Subject: Integrated Overflow Abatement Plan Modification
DOJ Case No. 90-5-1-1-08254

Integrated Overflow Abatement Plan Modifications

Subject: Southwestern Parkway Storage Basin
Minor Project Modification
IOAP Project No. L_OR_MF_105_M_13_B_A_0
DOJ Case No. 90-5-1-1-08254

South Fork Beargrass Creek
Lexington Rd and Payne St Storage Basin

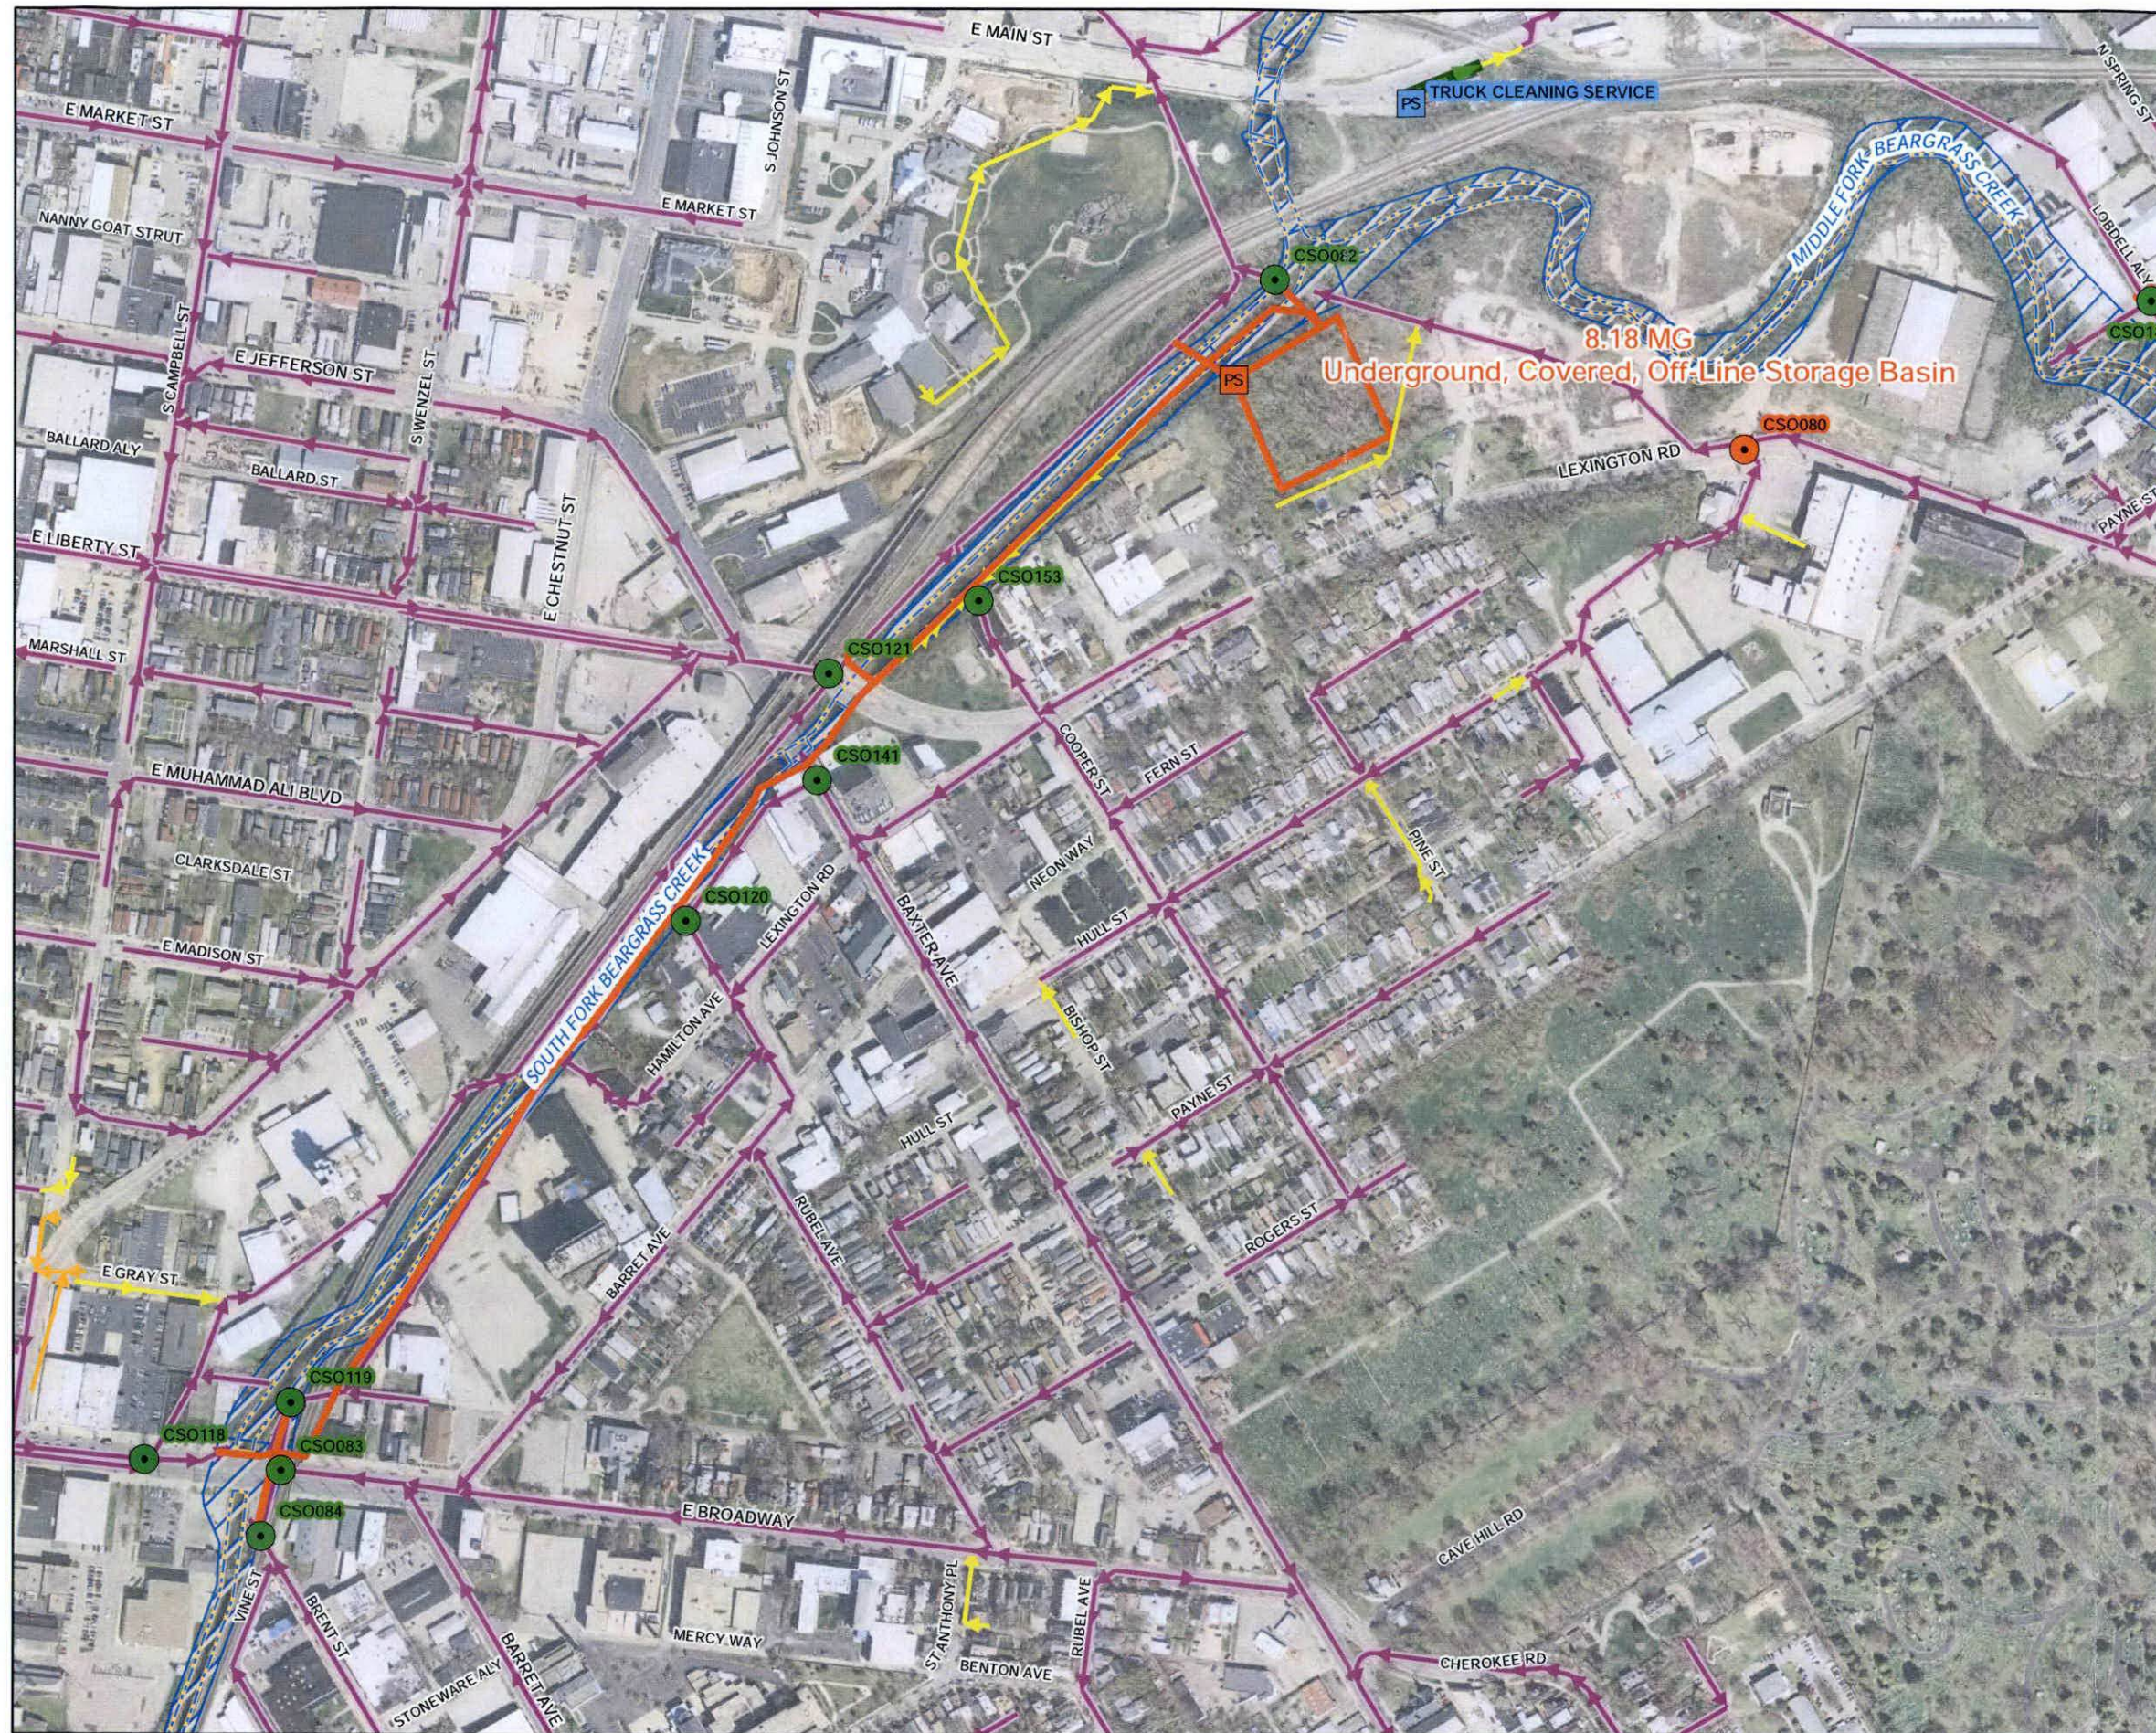
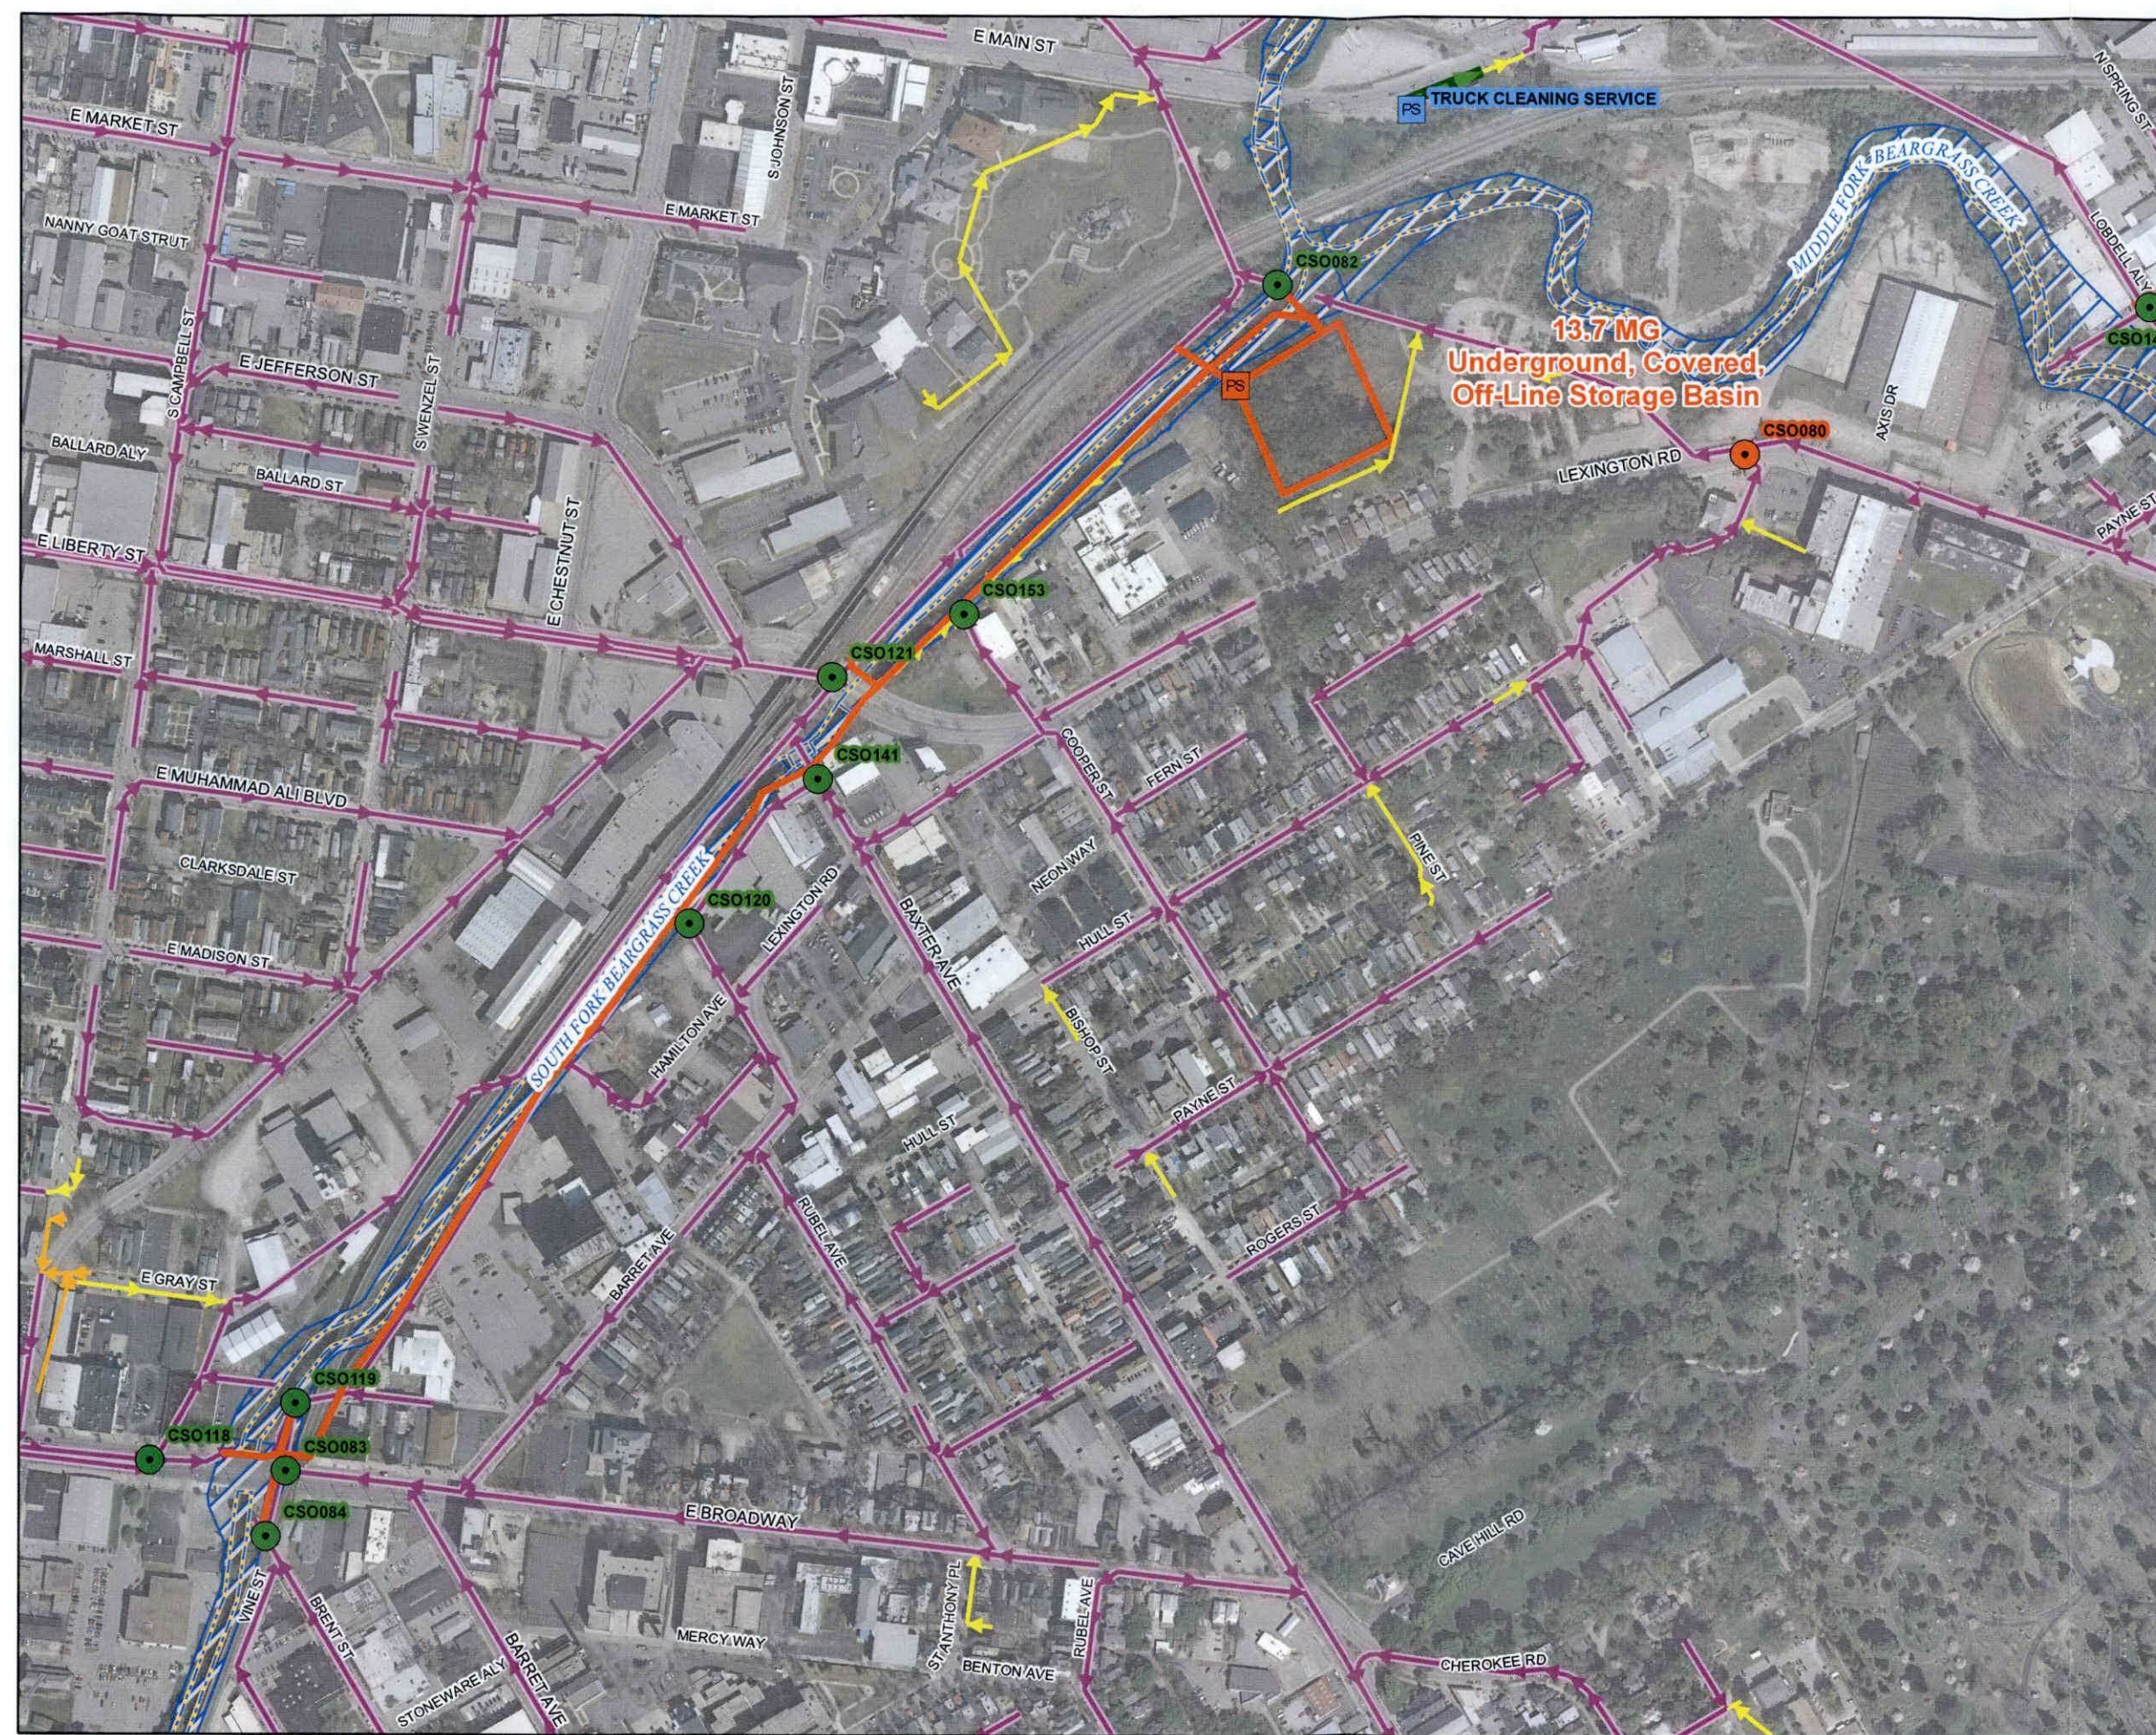
This project modification request includes increasing the Lexington road and Payne Street Storage Basin size from 8.18 MG to 13.7 MG. The level of control is proposed to remain at zero overflows per year in the typical year. The larger size is necessary to retain the zero overflow per year level of control given other changes that have happened in the system. No change in project completion date is proposed.
